UPDATE CHANGE NOTIFICATION # 16642Generic Copy

TITLE: Update Notification to FPCN16642 for Qualification of SOT23 3L, SOT23 5L & SOT23 6L Packages in Assembly and Test Site in LPS (China).

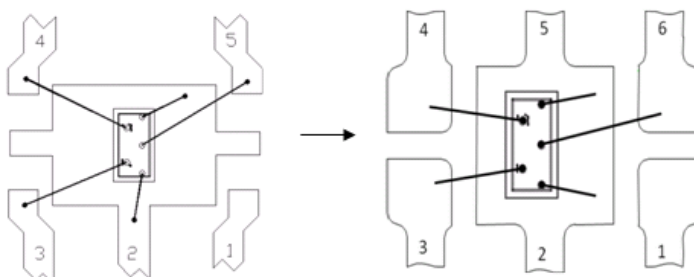
This is the final notification announcing that ON Semiconductor is adding assembly and test manufacturing capacity for SOT23 3L, SOT23 5L & SOT23 6L packaged ESD Protection products to Internal Assembly site at LPS, China. These products continue to meet RoHS requirement and are also Halide Free.

Package Change & Pin Configuration Change: The package for SOT23 5L devices will change to SC-74. Pin 5 will be replaced by Pin 6 of SC-74. Pin 5 of the SC-74 will be the same electrical connection as Pin 2.
